Contract #: 04-0120F4Cty: SF/ALA Rte: 80 PM: 13.2/13.9File #: 69.25B**QUALITY ASSURANCE -- NON-CONFORMANCE REPORT****Location:** Changxing Island, Shanghai, P.R. China**Report No:** NCR-000757**Prime Contractor:** American Bridge/Fluor Enterprises, a JV**Date:** 06-Jun-2010**Submitting Contractor:** Zhenhua Port Machinery Company, Ltd (ZPMC), Changxing Island**NCR #:** ZPMC-0719**Type of problem:**

Reference Description: ZPMC performed Heat Straightening repair on OBG Crossbeam Traveler Rails by deviating from the approved HSR

Subject: NCR No. ZPMC-0719

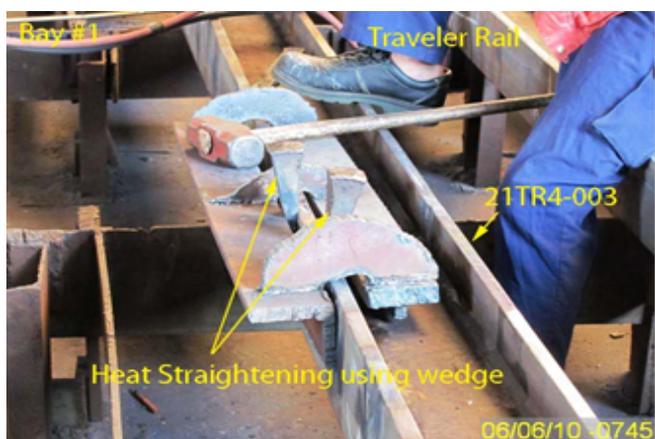
During the Quality Assurance (QA) random in-process visual inspection of Orthotropic Box Girder (OBG) Traveler Rails, this QA inspector observed that ZPMC personnel performed heat straightening of 2 traveler rails in the following ways:

- ZPMC personnel heated the areas to be straightened and mounted a temporary fixture to the flange and drove steel wedges between the fixture and flange.
 - The above procedure is not an approved heat straightening procedure as shown in HSR (B)-363, Revision 1.
 - The use of the wedges is not mention in the approved HSR.
 - Furthermore, after the removal of the wedges and fixture, this QA observed damages to the base material of the flanges caused by the steel wedges.
 - The affected Traveler Rails are identified as: 21TR4-003, 21TR3-003.
 - The material is A709 Grade 345.
- OBG Traveler Rails are located in the Bay 1.

Approved Heat Straightening Report HSR (B)-363, Revision:1: "Jack shall be used in a manner such that all forces are applied passively"

Caltrans Standard Specifications July 1999, Section 55-3.02 STRAIGHTENING MATERIAL; "If straightening is necessary, it shall be done by methods acceptable to the Engineer. Details for methods proposed for straightening shall be submitted in writing to the Engineer prior to their use. After straightening, evidence of fracture or other damage will be cause for rejection of the material."

AWS D1.5/2002 Section 3.7.3: "Members distorted by welding shall be heat straightened by mechanical means or by carefully supervised application of a limited amount of localized heat as approved by the engineer."

Reference Resolution: ZPMC will provide a revised HSR showing the activity that was performed in the shop. Also perform NDT of the base metal where the damage was observed.

This proposed resolution is accepted, action pending. Please provide a revised HSR and NDT results for these welds upon completion of the repairs. NDT results should be provided for both the base metal repairs and the welds between the flange and web.

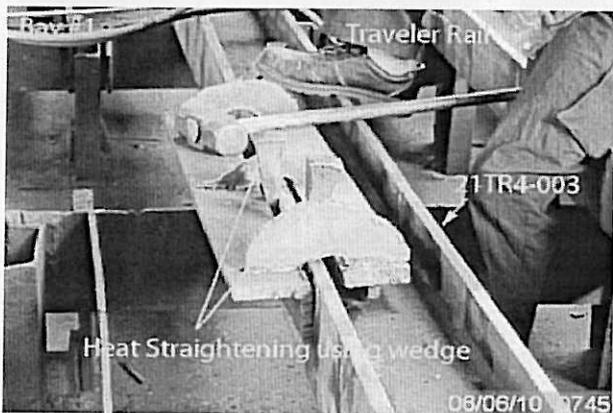
During the Quality Assurance (QA) random in-process visual inspection of Orthotropic Box Girder (OBG) Traveler Rails, this QA inspector observed that ZPMC personnel performed heat straightening of 2 traveler rails in the following ways:

- ZPMC personnel heated the areas to be straightened and mounted a temporary fixture to the flange and drove steel wedges between the fixture and flange.
- The above procedure is not an approved heat straightening procedure as shown in HSR (B)-363, Revision 1.
- The use of the wedges is not mention in the approved HSR.
- Furthermore, after the removal of the wedges and fixture, this QA observed damages to the base material of the flanges caused by the steel wedges.
- The affected Traveler Rails are identified as: 21TR4-003, 21TR3-003.
- The material is A709 Grade 345.
- OBG Traveler Rails are located in the Bay 1.

Approved Heat Straightening Report HSR (B)-363, Revision:1: "Jack shall be used in a manner such that all forces are applied passively"

Caltrans Standard Specifications July 1999, Section 55-3.02 STRAIGHTENING MATERIAL; "If straightening is necessary, it shall be done by methods acceptable to the Engineer. Details for methods proposed for straightening shall be submitted in writing to the Engineer prior to their use. After straightening, evidence of fracture or other damage will be cause for rejection of the material."

AWS D1.5/2002 Section 3.7.3: "Members distorted by welding shall be heat straightened by mechanical means or by carefully supervised application of a limited amount of localized heat as approved by the engineer."

Contractor will submit an updated HSR for approval, and provide NDT report to show that the base metal and affected welds were not damaged by the heat straightening. Contractor will monitor the unapproved heat straightening by ensuring coverage during welding and repair operations. Contractor will identify the welders and inspectors who are not follow the contract specifications for further training and otehr actions.

Contractor submitted the updated HSR, and NDT report provided. The NDT report showed the base metal and affected welds did not damage by heat straightening. Contractor will continue to montior the unapproval heat straightening, and training or other action will be taken if the welders and inspectors do not follow the contract specification continuously.
